FRESNO UNIFIED SCHOOL DISTRICT VIKING ELEMENTARY SCHOOL MULTIPURPOSE BUILDING HVAC REPLACEMENT

VIKING E.S. KITCHEN HVAC ADDITION

Bid No. 21-43, Viking and Vinland Elementary schools and Cooper Middle School Kitchen HVAC Additions

Issue	BID SET - ADDENDUM 1
Date	10.20.2020
Job Number	19000643.00
Drawn	ZM
Checked	JM
Approved	ED

DEMOLITION FLOOR PLAN

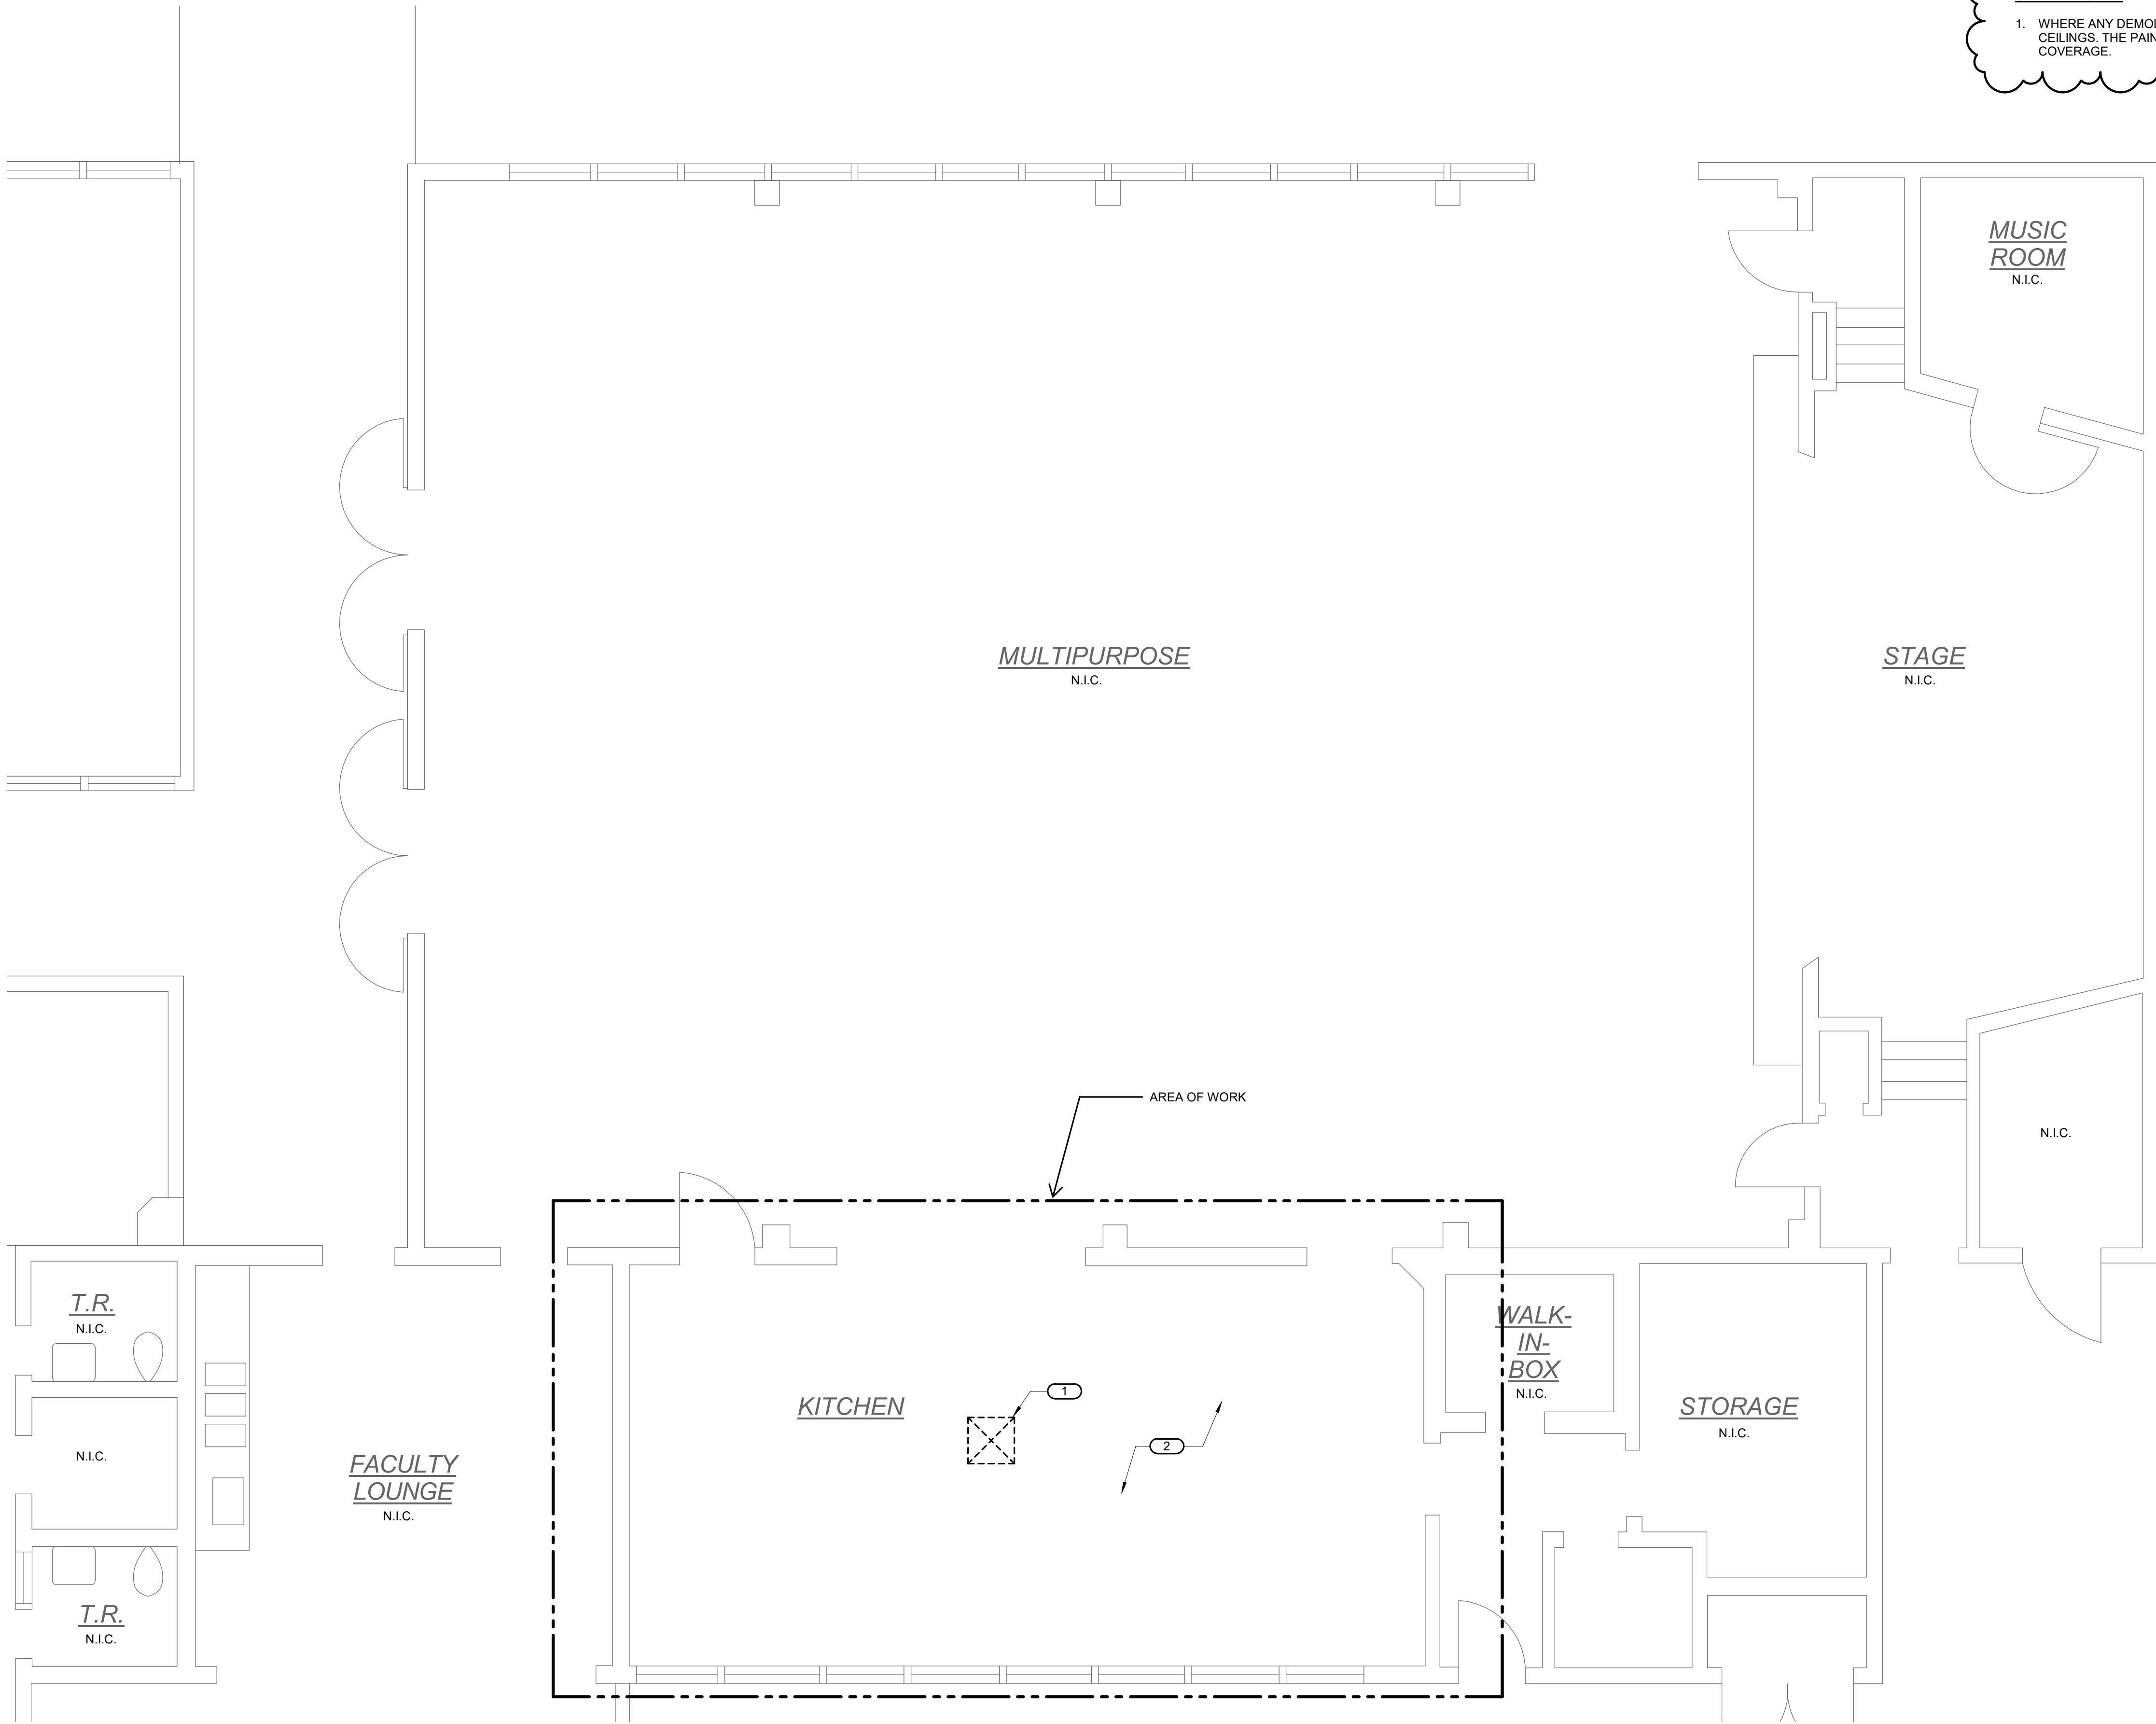
- 1.1 SHEET M2.1
 - A. Added patch and paint general note.
 - B. Modified keynote 2 stating to remove existing power and controls wiring.
- 1.2 SHEET M2.2

1. EXISTING SUPPLY DUCT AND DIFFUSER FOR EXISTING EVAPORATIVE COOLER TO BE DEMOLISHED.
2. FIELD LOCATE ELECTRICAL CONTROLS/SWITCHES ASSOCIATED WITH EXISTING EVAPORATIVE COOLER BEING DEMOLISHED AND REMOVE EXSISTING POWER AND CONTROLS WIRING, CONDUITS AND SWITCHES. PATCH AND PAINT WALLS AND CEILING TO MATCH EXISTING.

REMODEL FLOOR PLAN

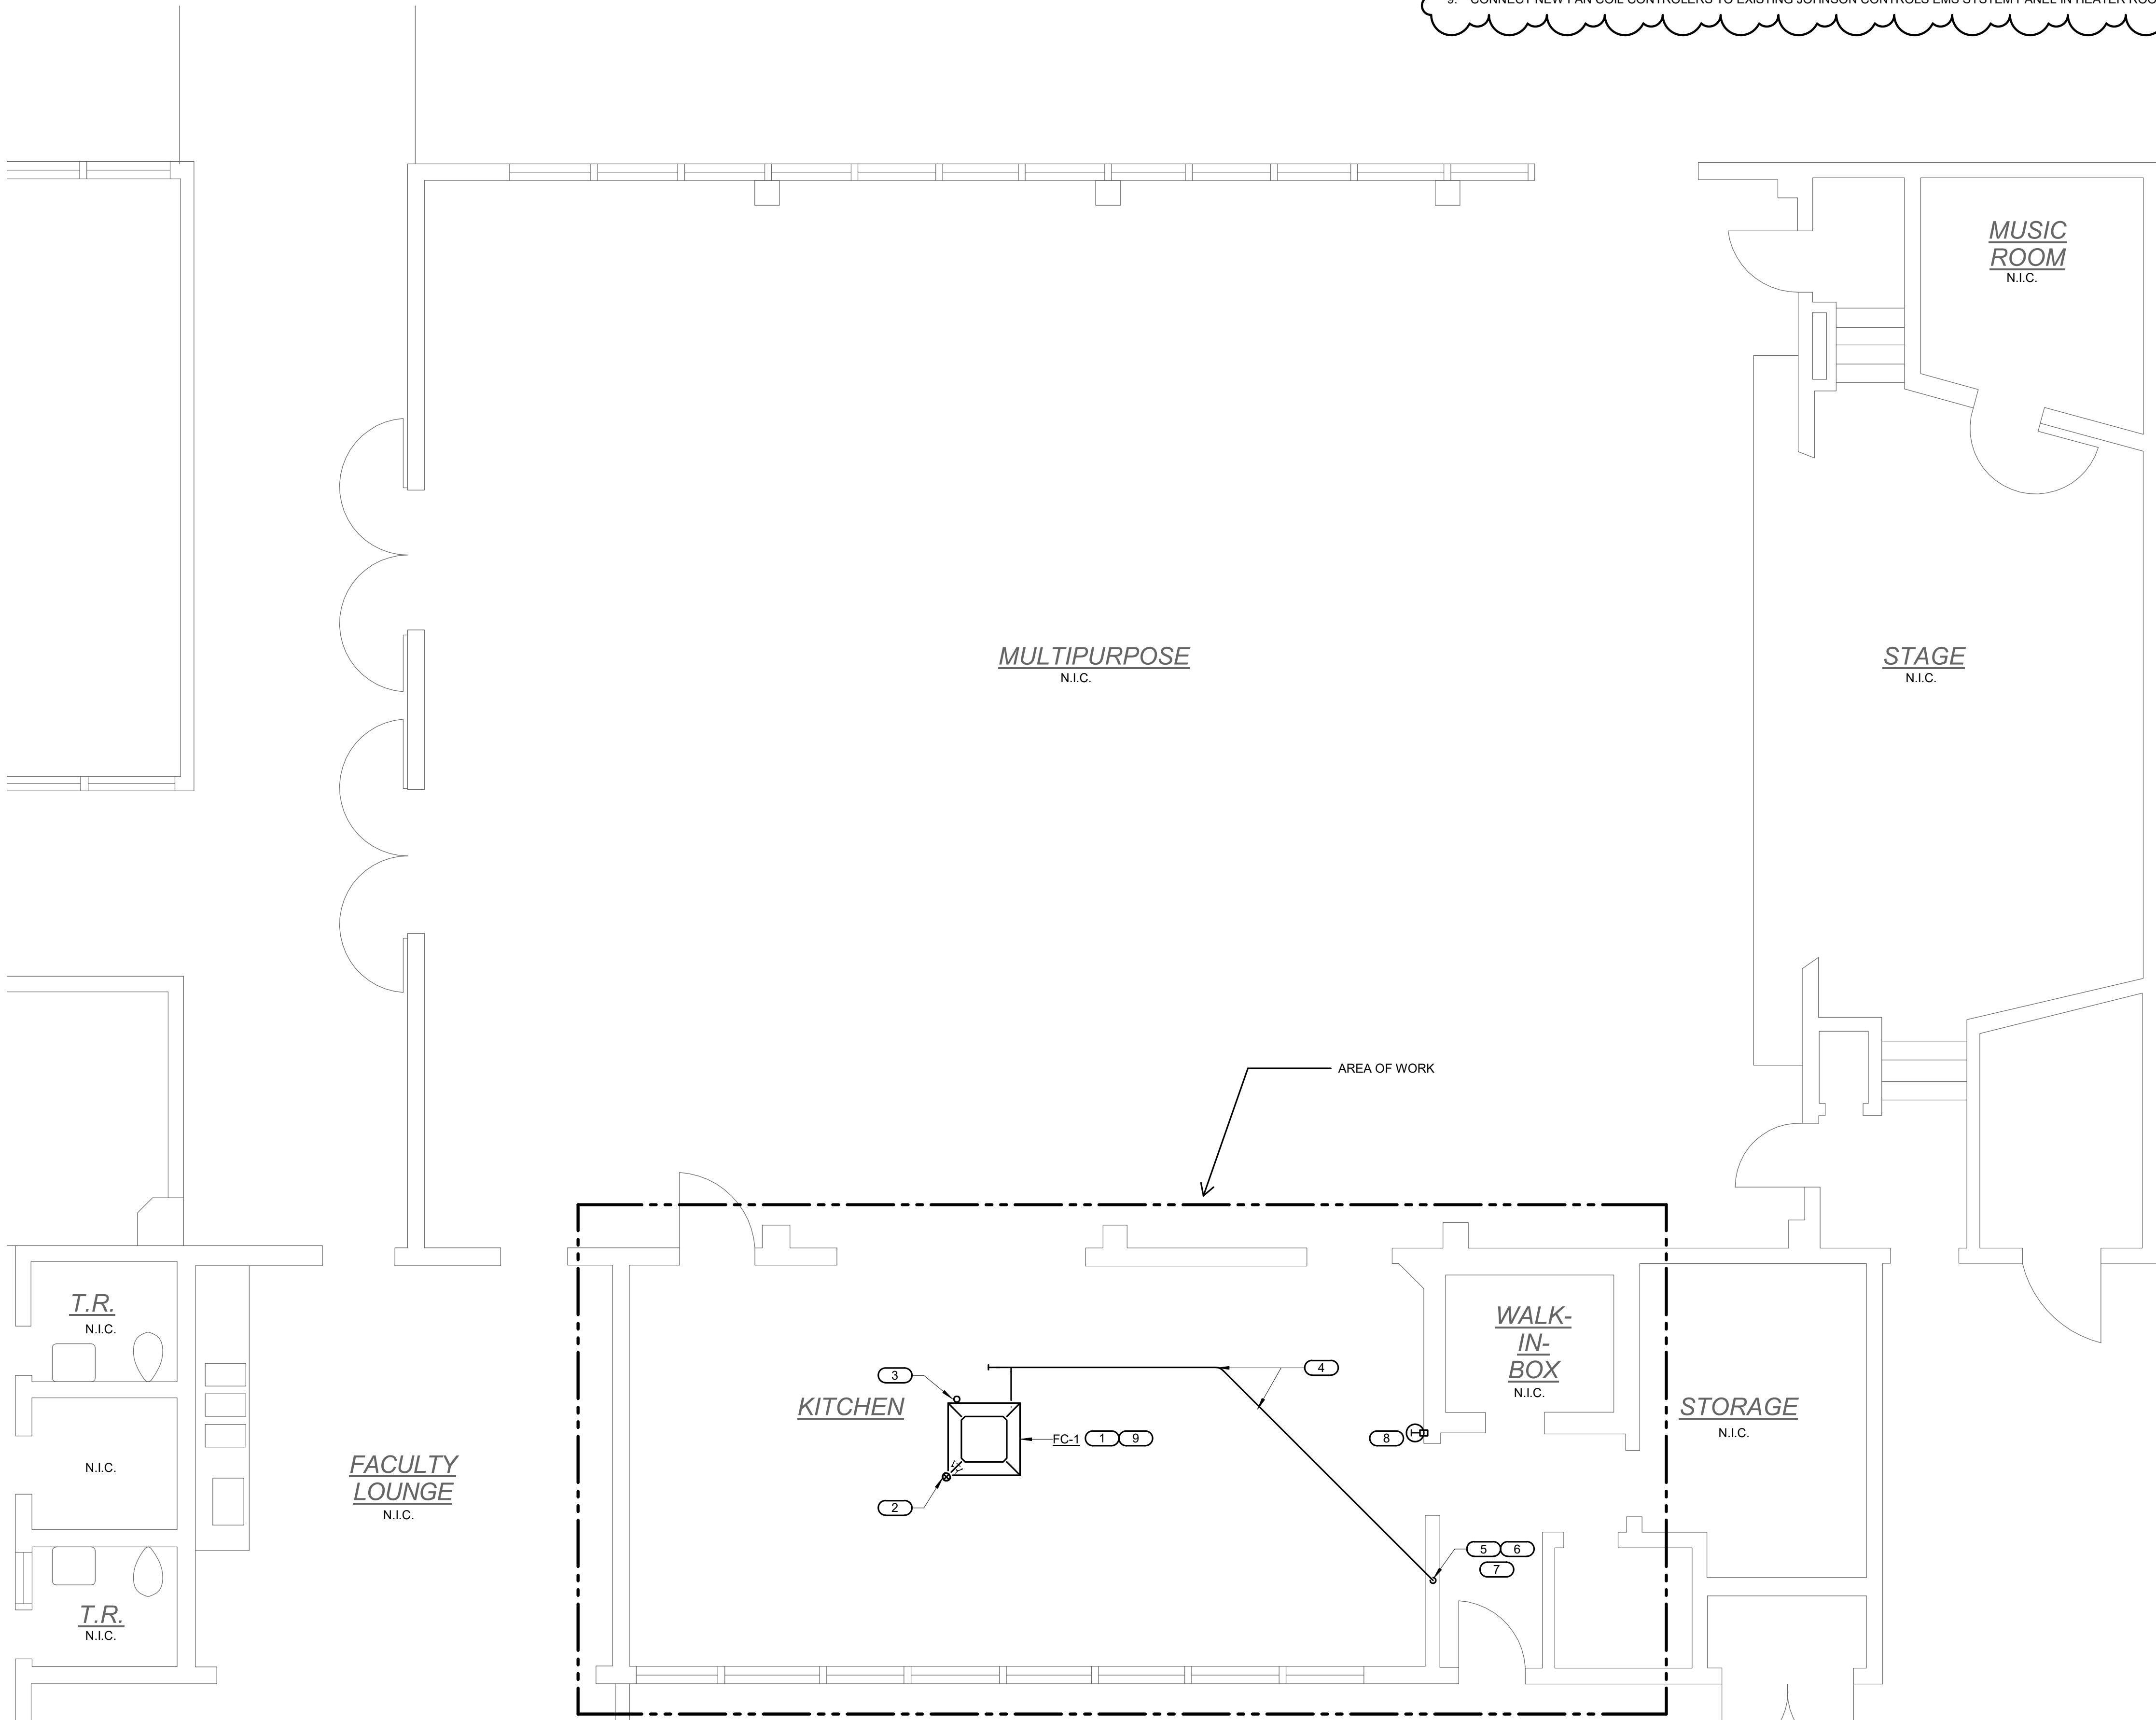
- A. Modified demolition keynotes.
- 1.3 SHEET M3.1
 - A. Modified keynotes.
 - B. Added general note.
- 1.4 SHEET M3.2
 - A. Added keynote 6.
- 1.5 SHEET M4.1

1. NEW FAN COIL TO BE INSTALLED IN EXISTING OPENING IN CEILING.
2. NEW 4"Ø OSA DUCT UTR TO NEW ROOF CAP. REFER TO DETAIL 5/M4.1. BALANCE OSA TO MIN 95 CFM.
3. REFRIGERANT LINES IN CEILING SPACE TO FC-1.
4. 3/4" CONDENSATE LINE IN CEILING SPACE.
5. 3/4" CONDENSATE LINE IN (E)WALL. REMOVE DRYWALL BETWEEN STUDS IN ORDER TO INSTALL PIPE IN WALL. PATCH AND PAINT WALL TO MATCH EXISTING AFTER PIPE INSTALLATION.
6. CONNECT CONENSATE LINE TO (E)SINK TRAP (FIELD LOCATE). INSTALL NEW TRAP WITH CONDENSATE LINE CONNECTION IF NECESSARY. REFER TO DETAIL 6/M4.2.
7. RUN NEW CONDENSATE LINE IN (E)CASEWORK TO (E)SINK. FIELD COORDINATE EXACT ROUTING OF PIPING WITHIN CASE WORK TO MINIMIZE DISRUPTION AND SPACE CONSIDERATION.
8. INSTALL NEW DDC THERMOSTAT.
9. CONNECT NEW FAN COIL CONTROLLERS TO EXISTING JOHNSON CONTROLS EMS SYSTEM PANEL IN HEATER ROOM. ROUTE CONDUIT AS NEEDED.

EQUIPMENT CURB/PLATFORM FLASHING

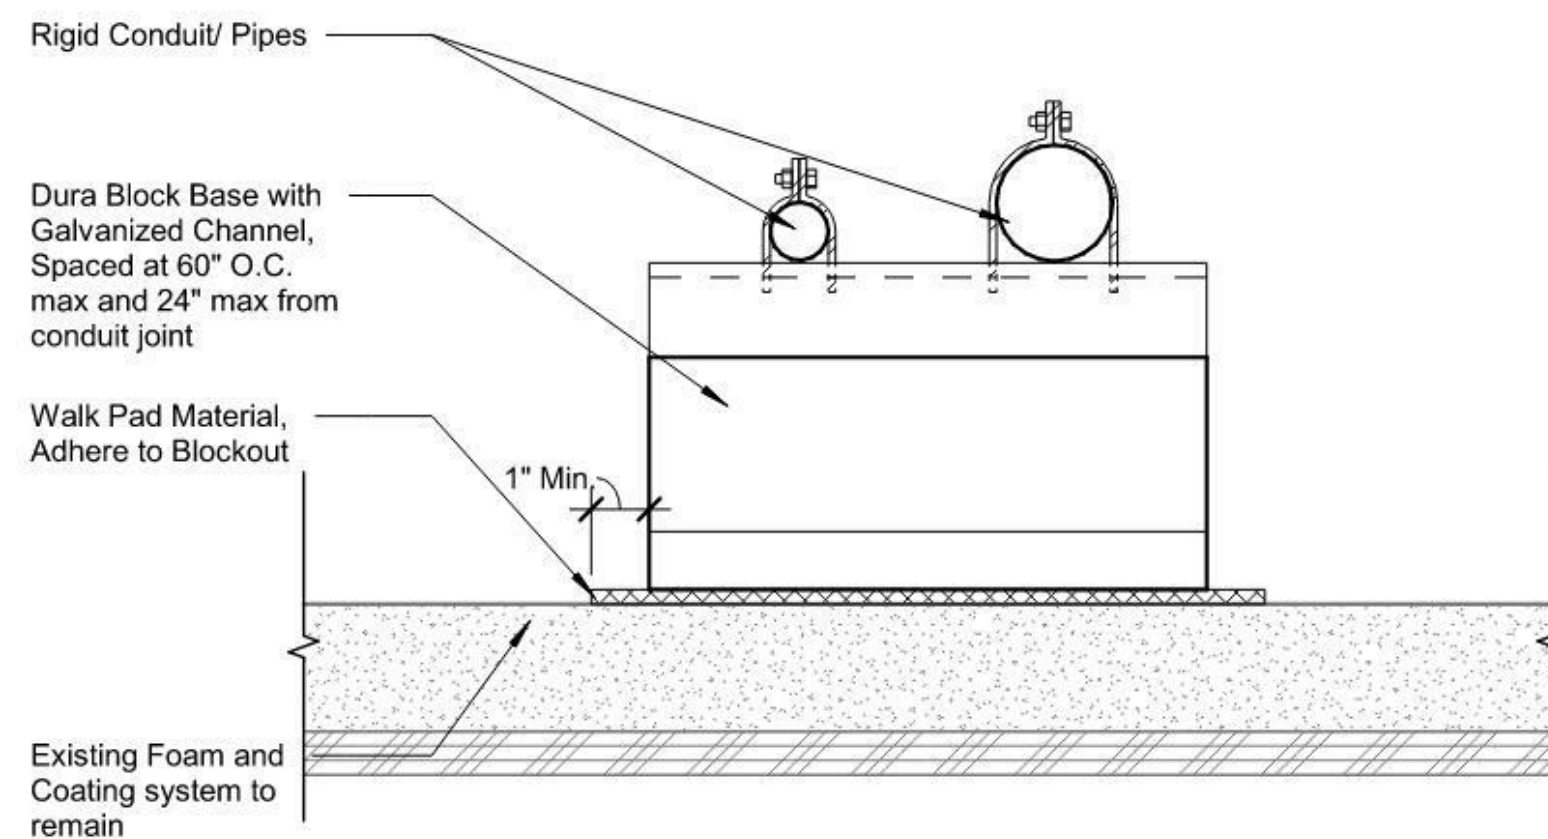
- A. Modified detail 1 "Condensing Unit On Roof" to FUSD approved detail.
- 1.6 SHEET M4.2
 - A. Relocated detail 3 to Sheet M5.1.
 - B. Modified detail 4. Added FUSD approved detail "Sprayed Polyurethane Foam Equipment Platform."

DETAIL IS FOR WATERPROOFING ONLY. FOR PLATFORM CONSTRUCTION AND EQUIPMENT ANCHORAGE REFER TO 1/M4.1.

SPRAYED POLYURETHANE FOAM, CONDUIT SUPPORT

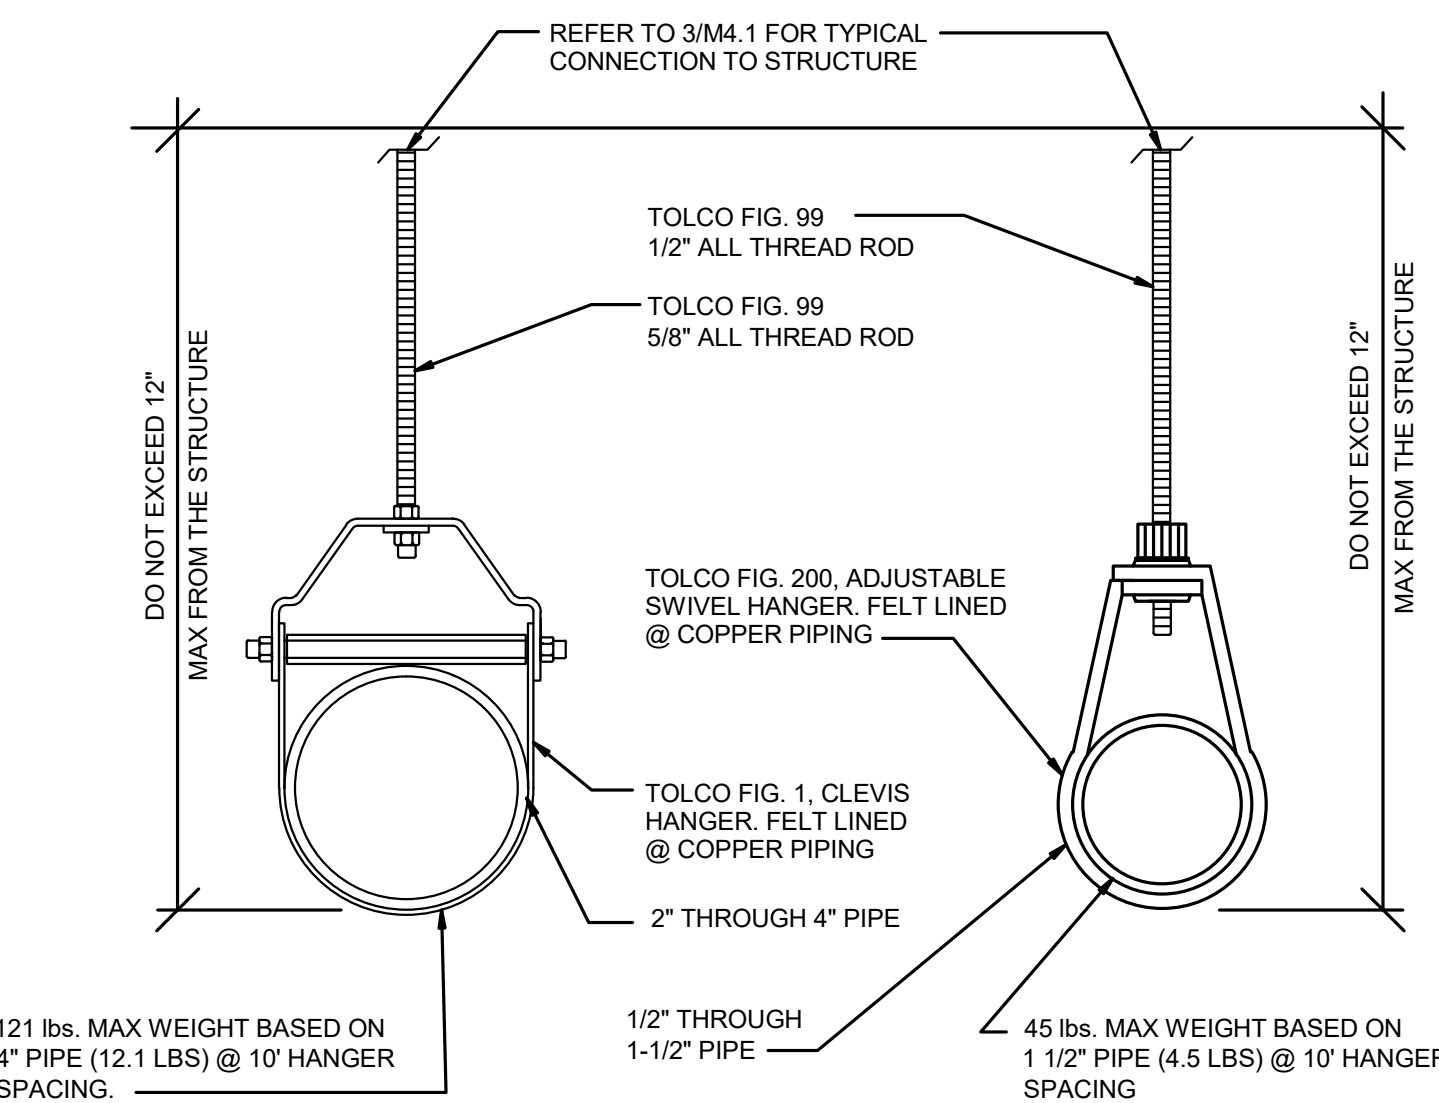
- C. Modified detail 6 "Condensate Connection To Lavatory."
 - D. Modified detail 8 "Sprayed Polyurethane Foam, Conduit Support" to FUSD approved detail.
